3018.96-002

**Subject:** Addendum to the November 12, 1996 Work Plan for 5050 Coliseum Way and 750-50th Avenue, Oakland, California

VOLVO GM  
**Proposed Soil and Groundwater  
 Sampling Locations and Temporary  
 Piezometer Locations**

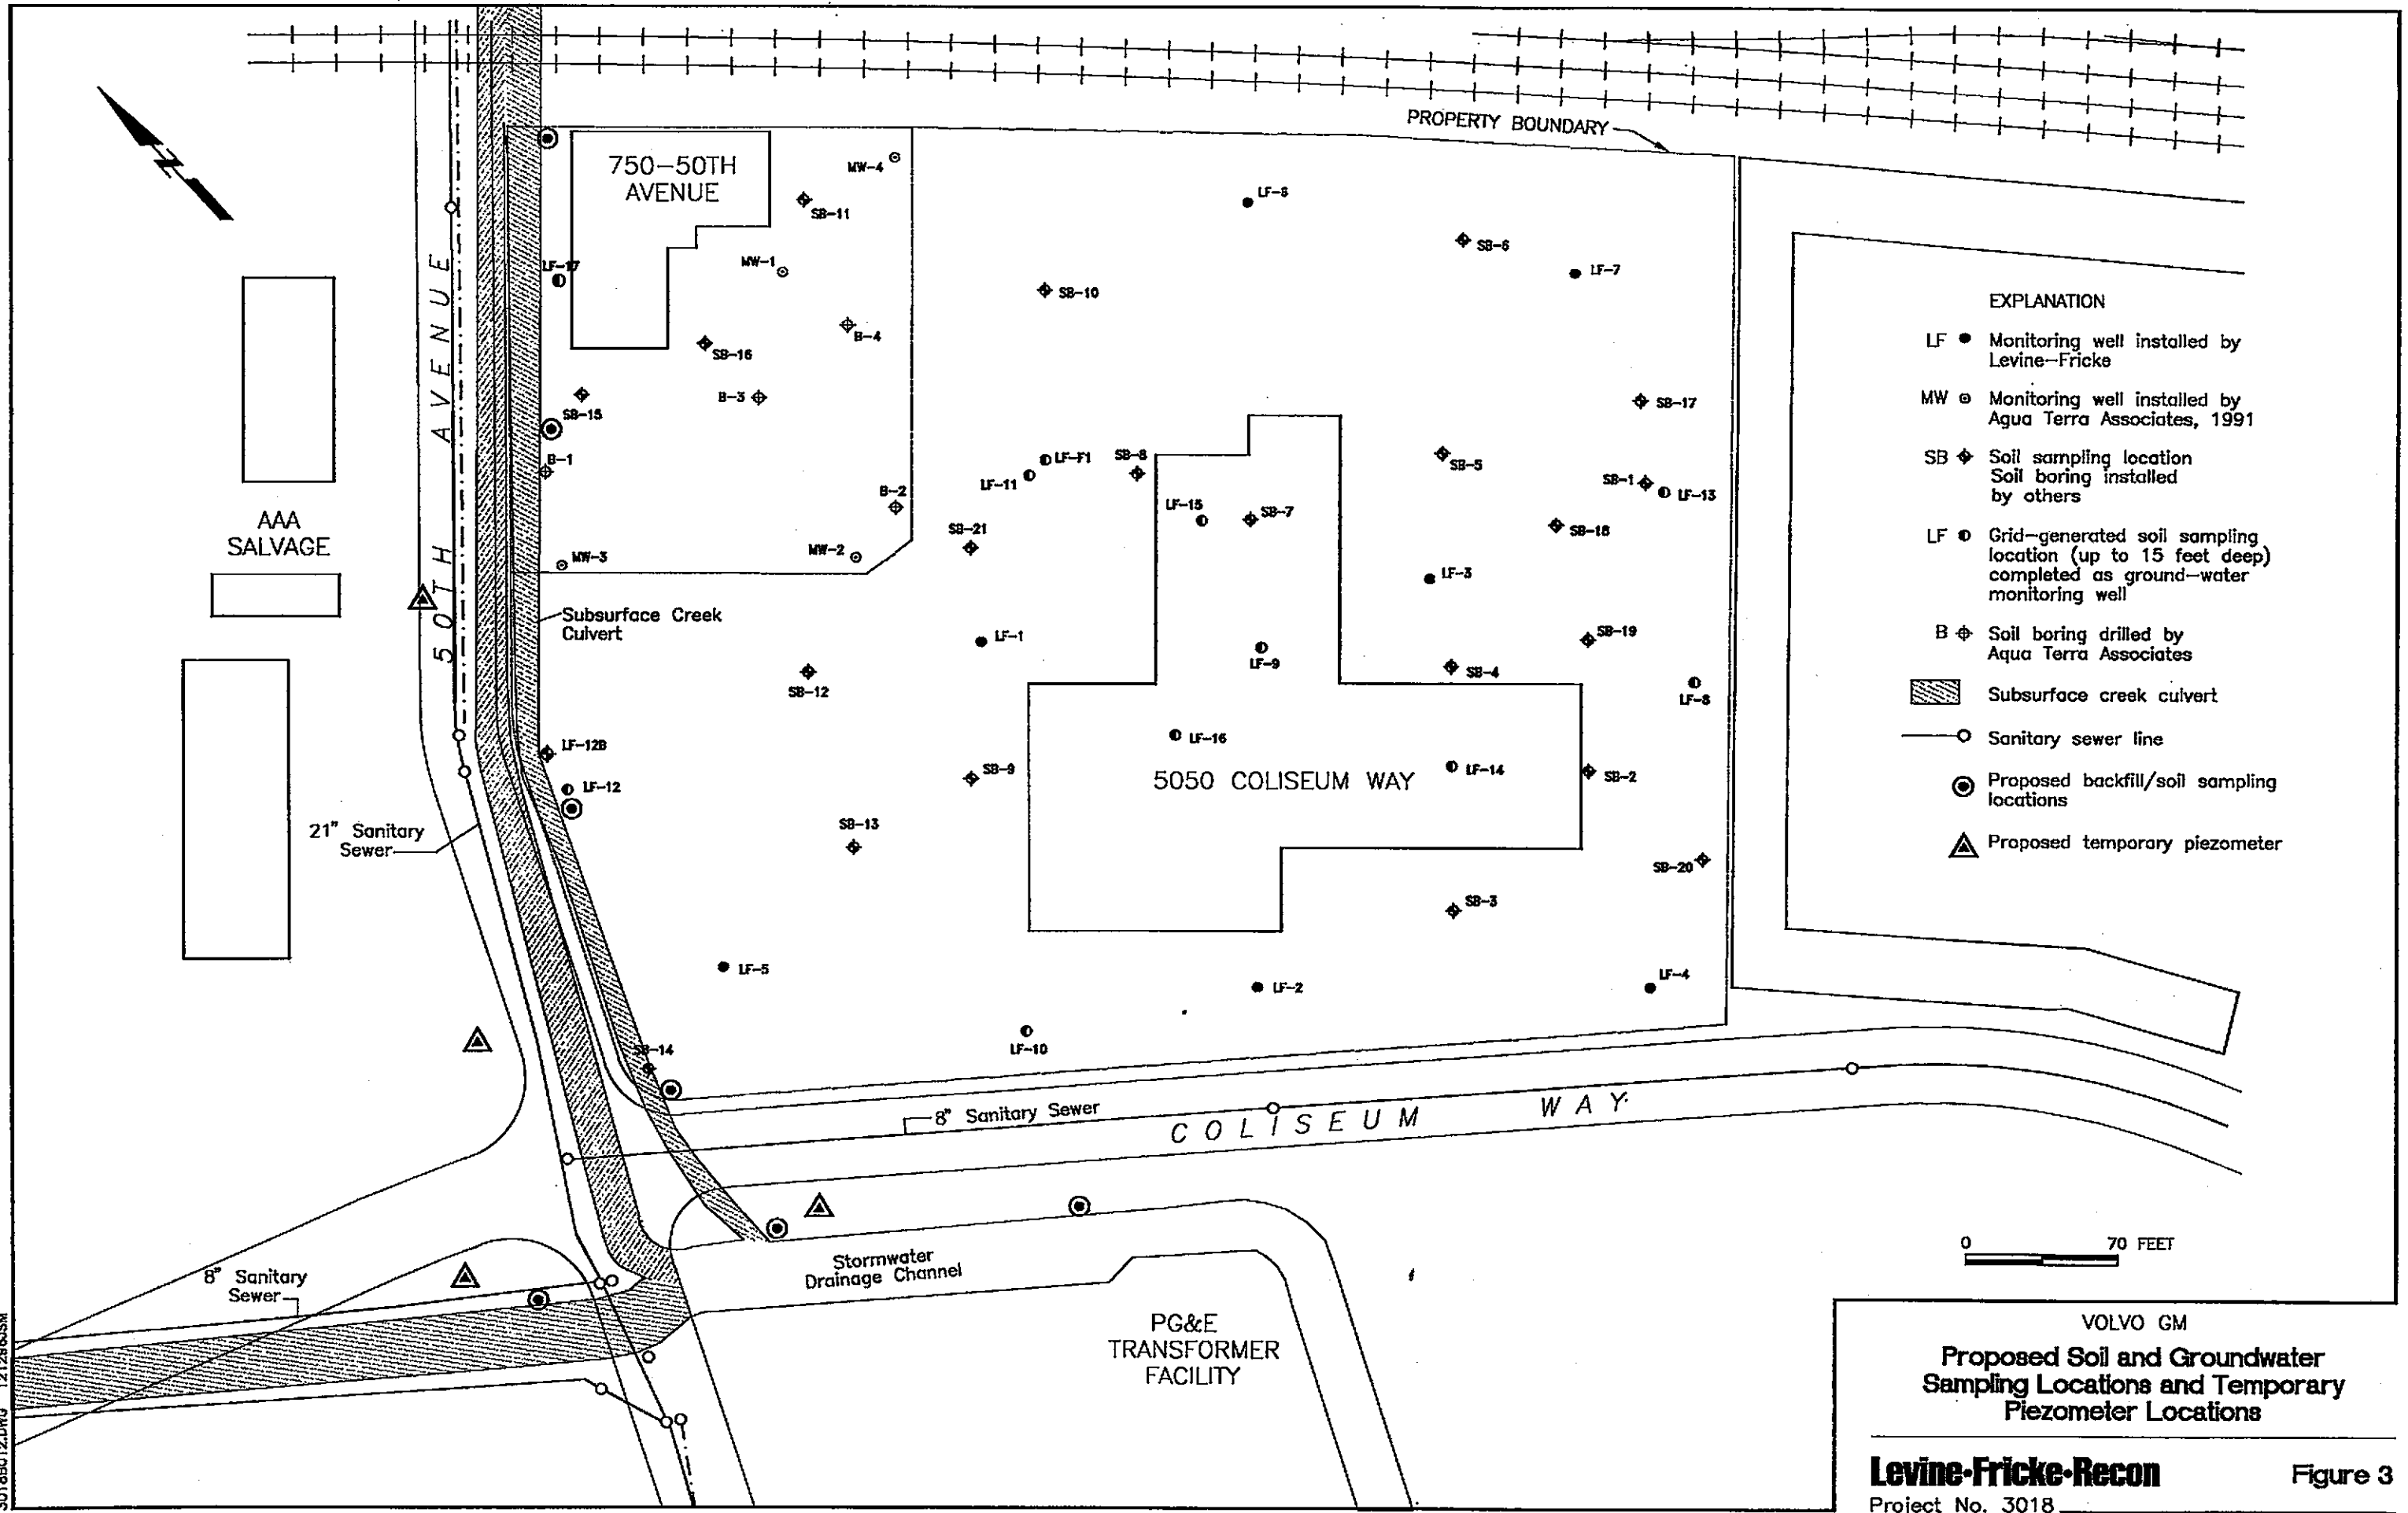
The off-site piezometers will be completed as a permanent installation, rather than temporary piezometers so that quarterly water levels may be collected for one year as requested by the RWQCB.

The off-site piezometers will be sampled immediately after they are installed and immediately before they are removed. Other sampling may be conducted according to the results of the first sampling event.

LFR will attempt to install one additional off-site piezometer across 50th Avenue in the right-of-way adjacent to the AAA Salvage facility. The approximate location is shown on revised Figure 3. The actual location of this additional piezometer as well as the location of the other three piezometers will depend on access and subsurface limitations.
